ACCELERATED DISTRIBUTION DEMONSTRATION SYSTEM

SUBJECT: Responds to request for addl info re 10CFR50.62 (ATWS Rule).

Subject: Palo Verde Nuclear Generating Station
Units 1, 2 and 3
Response to Request for Additional Information -
10 CFR 50.62 (ATWS Rule)
File: 89-056-026

APS Response to Request for Additional
Information - DSS Modification

DIAGRAM A

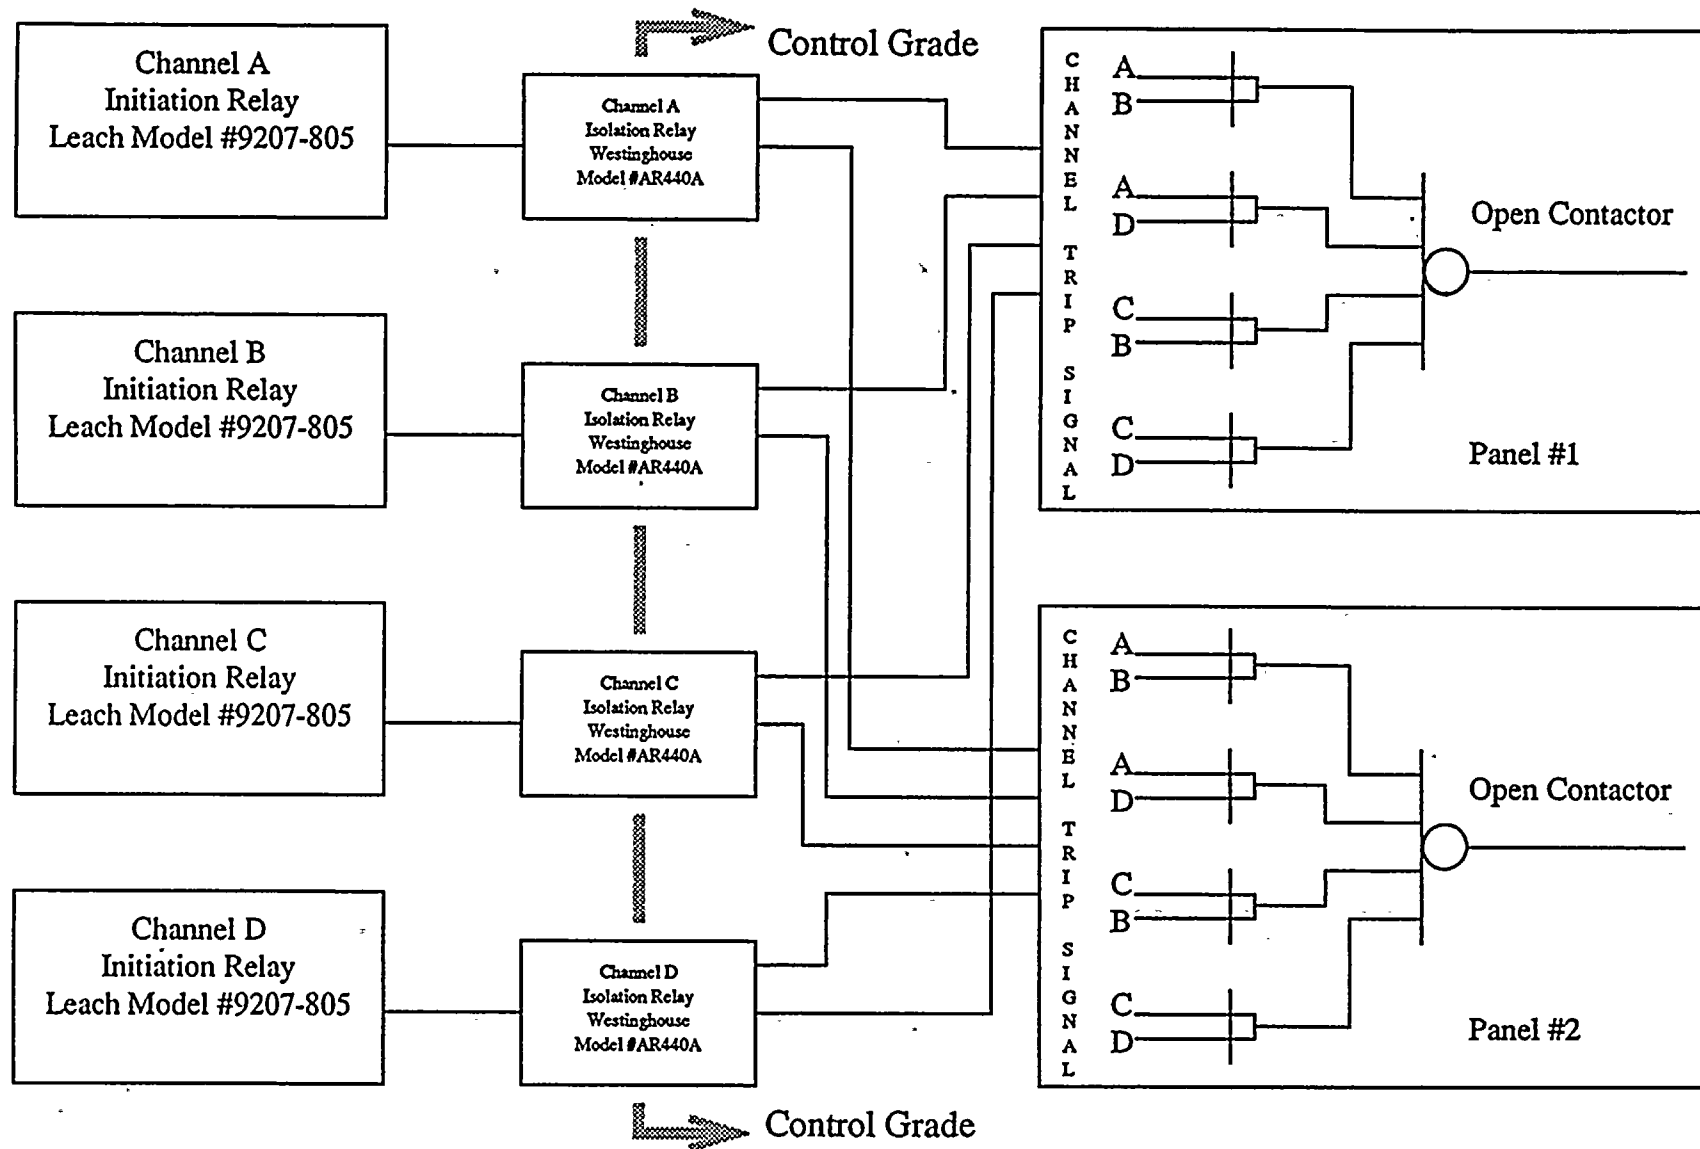
Item (2) (a) Provide detail and show on a block diagram the selective logic network that opens the MG Set output load contactors.

Item (2) (b) On the selective logic network block diagram indicate the control grade portion of the circuits and show the location of the isolators.

Diagram A (attached) reflects the Diverse Scram System (DSS) modification and the selective logic that will open the Motor-Generator (M-G) Set output load contactors.

The control grade portion of the ATWS DSS modification is depicted on Diagram A (attached).
